PDR-016
RESPONSE TO FREEDOM OF
INFORMATION ACT (FOIA) REQUEST

FOIA-88-18

SUBJECT: NOTICE OF VIOLATION (NRC INSPECTION REPORT 50-445/87-27;
50-446/87-20)

AFW FAN MOTORS AGENDA

BACKWARD INCLINED (forward curved) FAN
 INTENDED BY WESTINGHOUSE

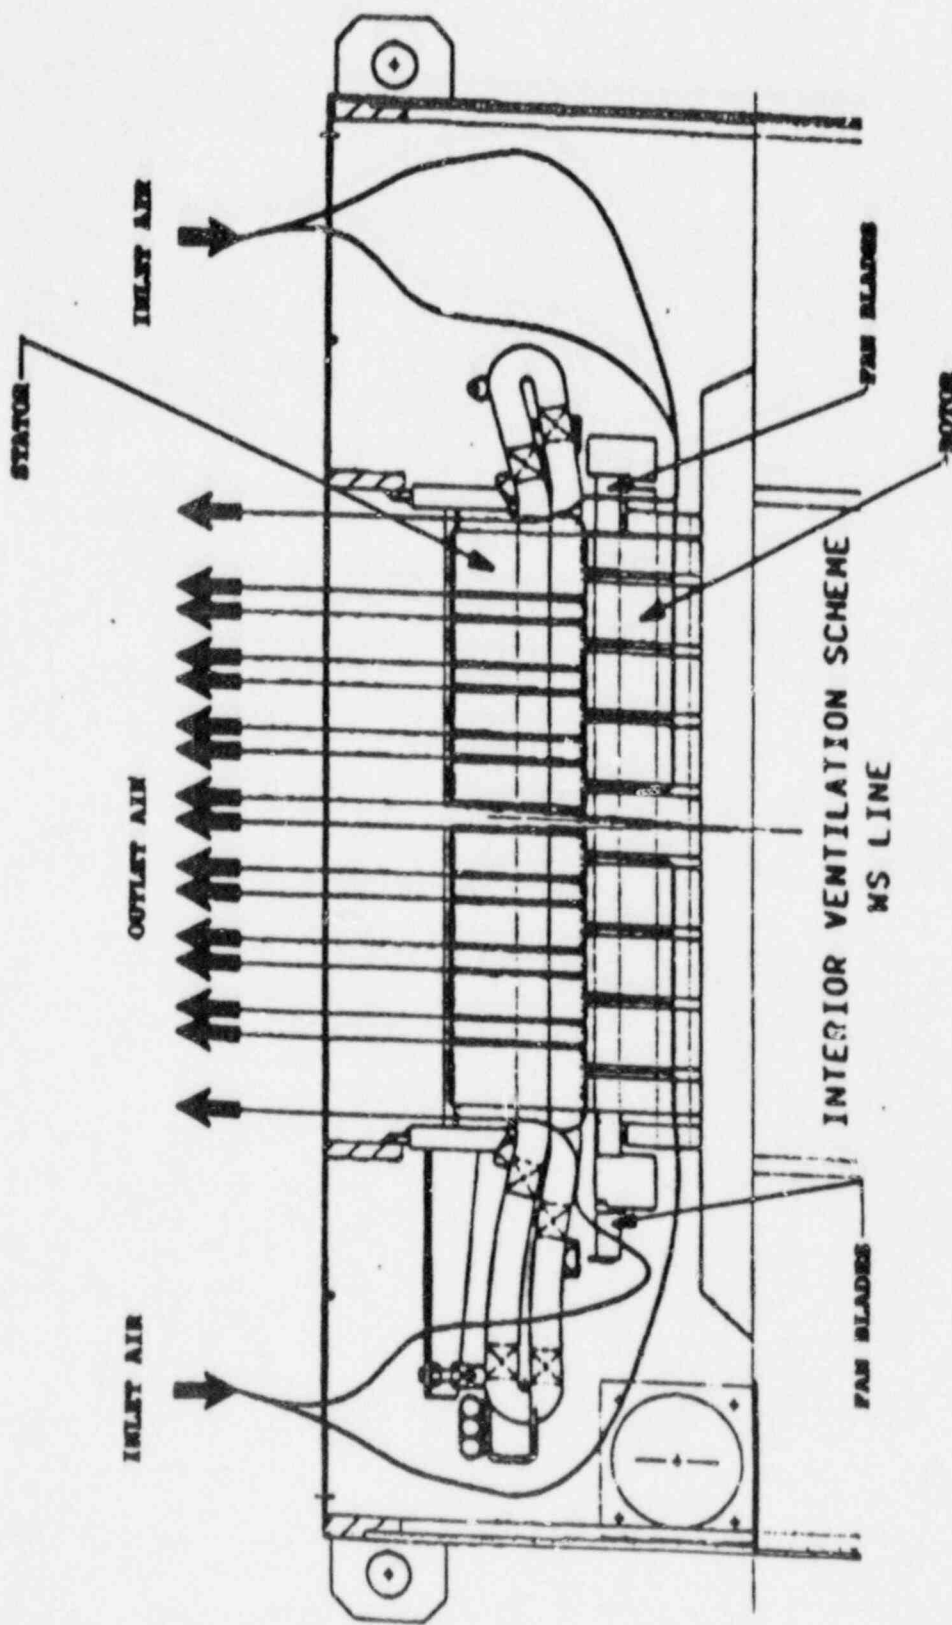
very unusual case

standard wiring procedure
